Noise Feasibility Study
Proposed Residential Development
Wyndham Street and Main Street
City of Mississauga, Ontario

January 24, 2020

HGC Engineering Project Number: 01700353
City of Mississauga File Numbers: OZ 17-20 & T-M17007 W11

As requested, we have prepared the following supplementary information regarding the Noise Feasibility Study, for the proposed residential development located at Wyndham Street and Main Street, in response to comments received by the City of Mississauga's Planning and Building Department.

Figure 2 - Proposed Site Plan

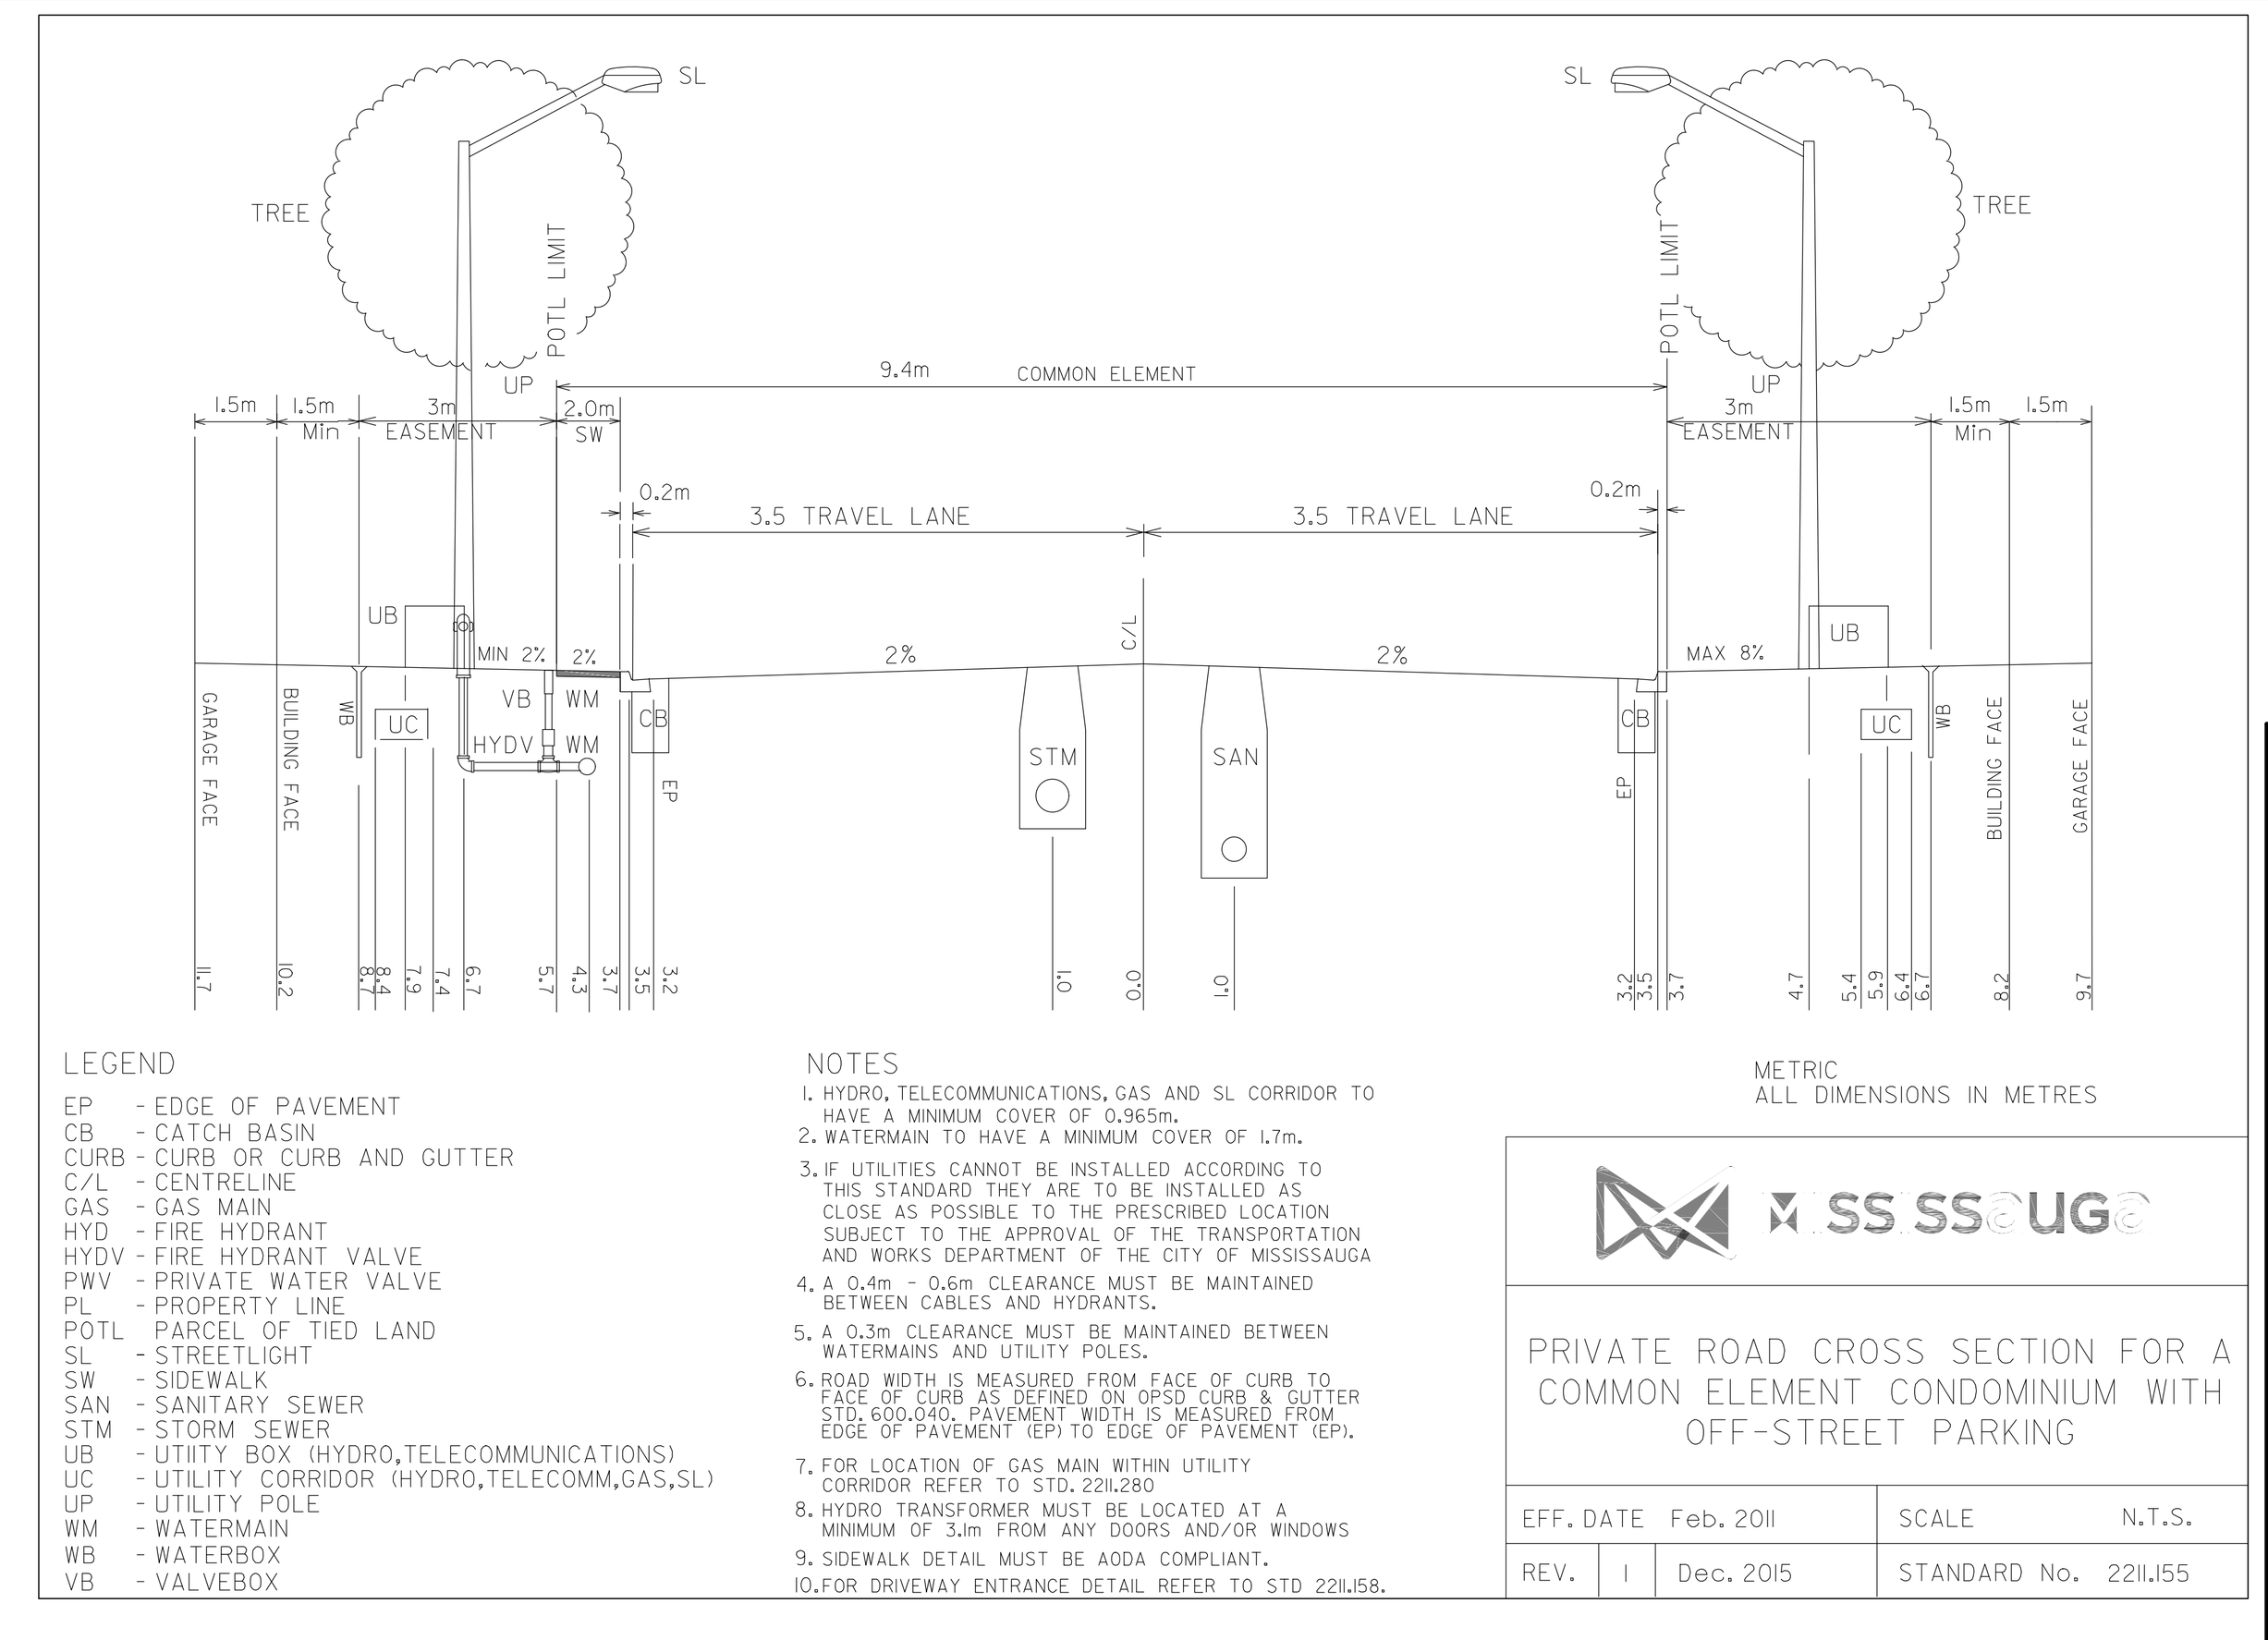
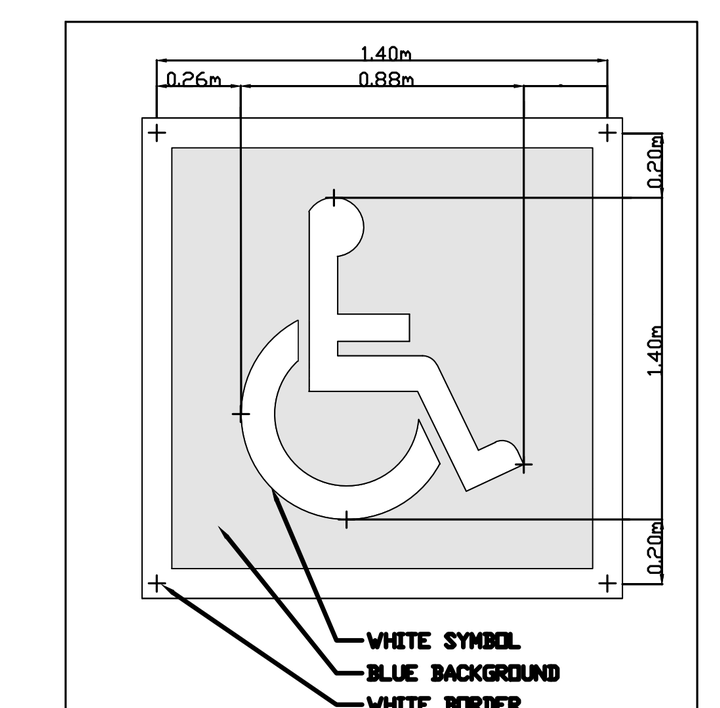
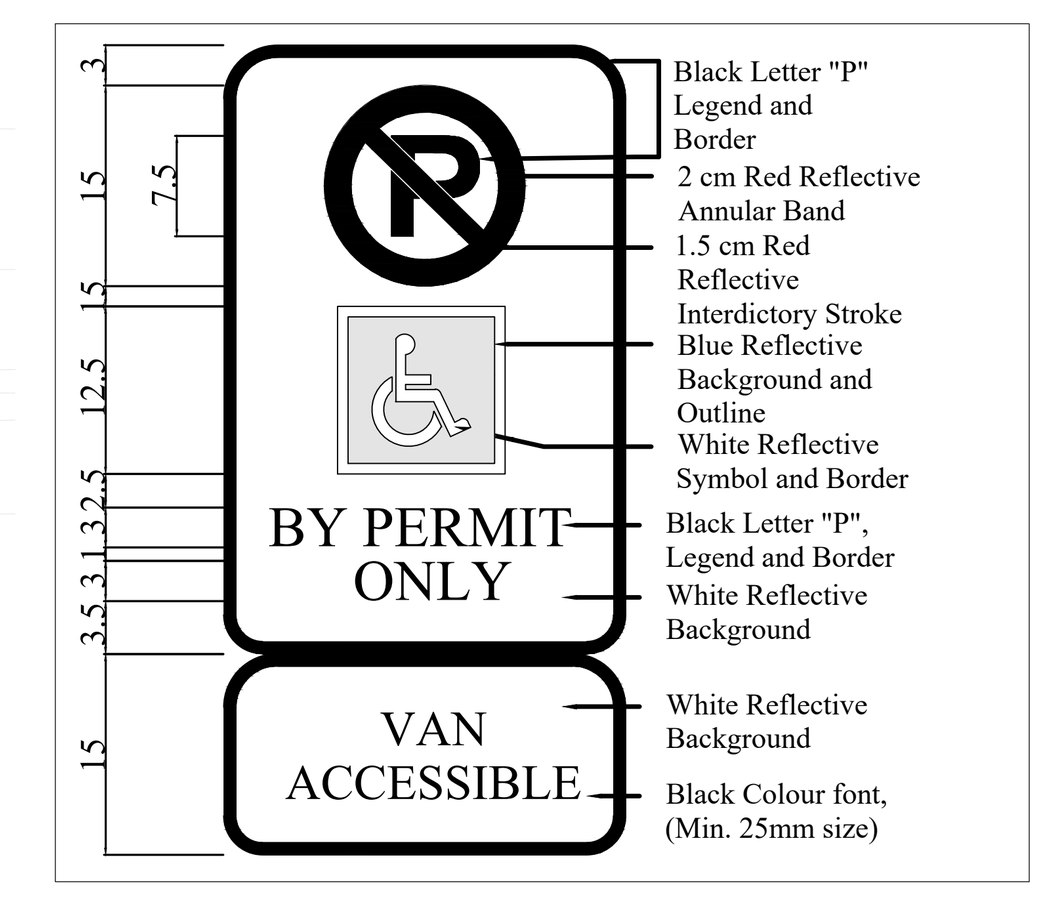
iii. Confirm if for the freehold Unit 4 exposed to Wyndham St. the predicted sound levels without mitigation is within the limits and show so on Table 3, page 5.

Please see revised the site plan.

Report has been revised to be consistent with latest site plan.

Figure 3 - Proposed Site Plan Showing Ventilation Requirements

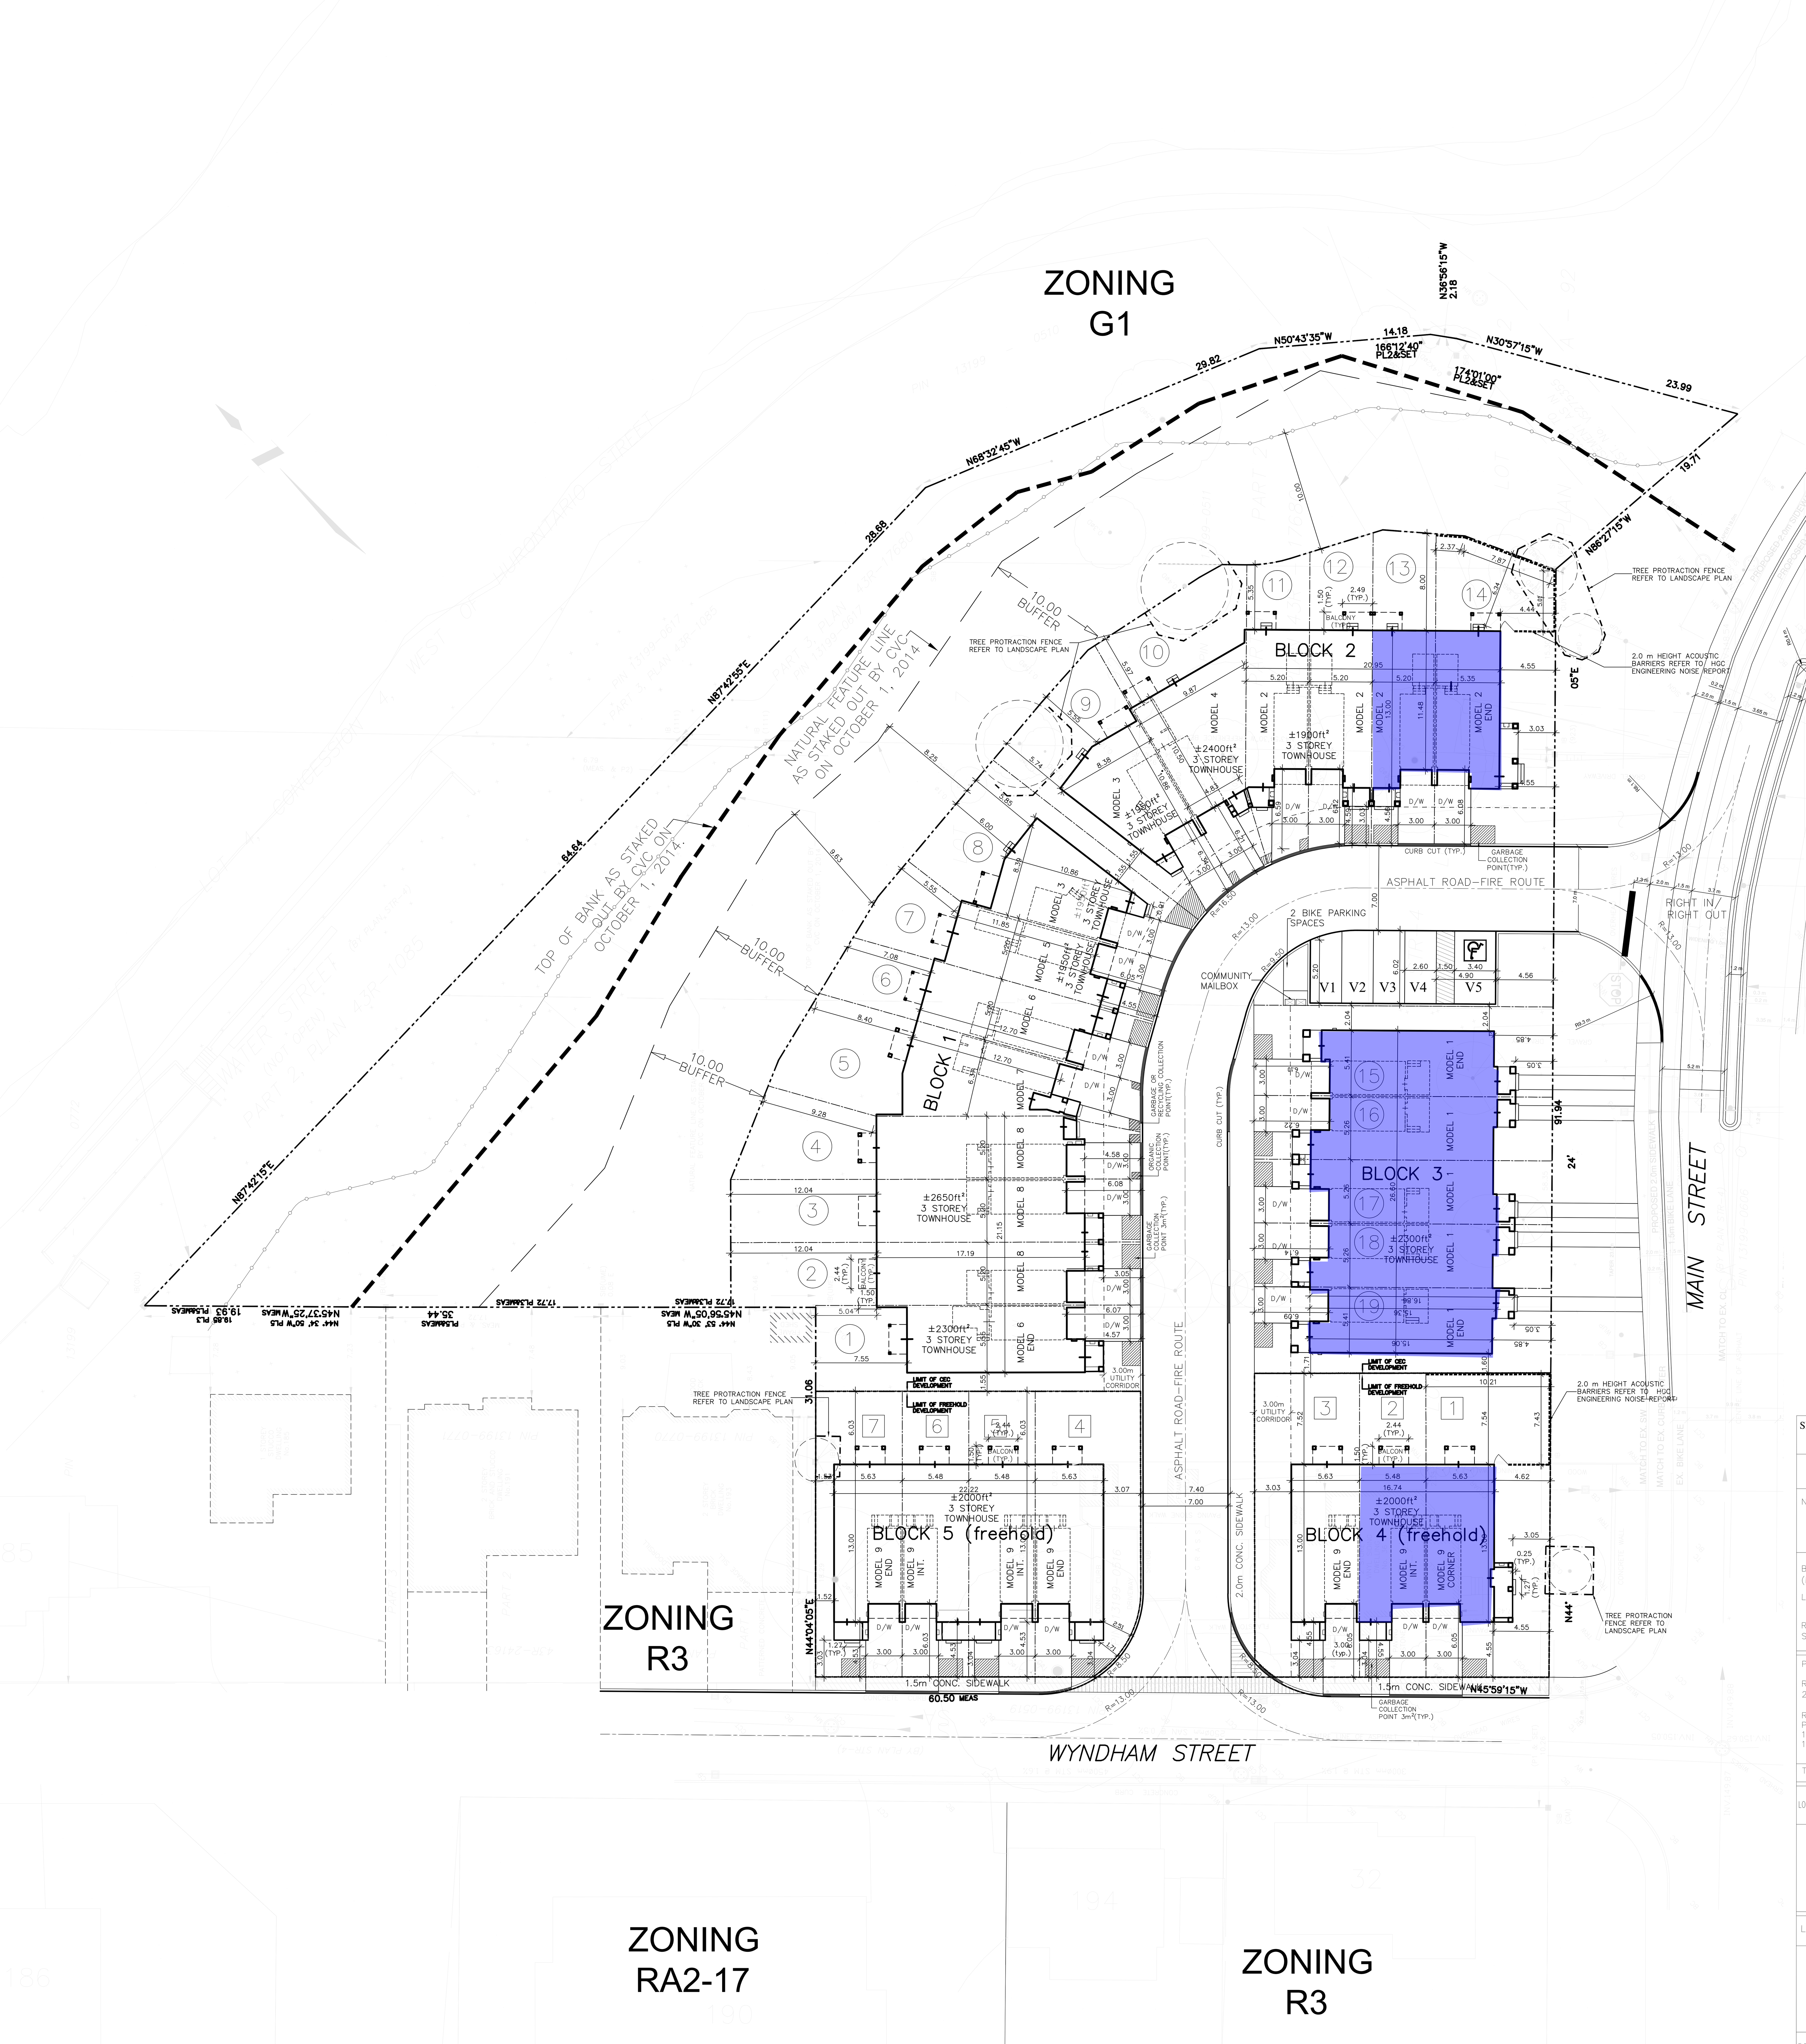
14. Updated June 06/2019 comment remains: The updated noise study has not been received with this submission. Acoustic fences along Main Street should be setback to 3.0 meters matching the townhouse porches. Acoustic fences should not project past the front porch of the townhouses of Block 1 (Freehold) and Block 2 (CEC). Amend the noise study to reflect these changes.

vi. As a new configuration of the proposed Noise barriers is presented within the drawings supporting the 2nd submission, the Noise report is to be updated to provide the noise levels achieved with this new configuration.

Per comments from civil engineering, the acoustical fence setback cannot be revised. The planned fence setback is as is to allow for a stormwater pipe easement.
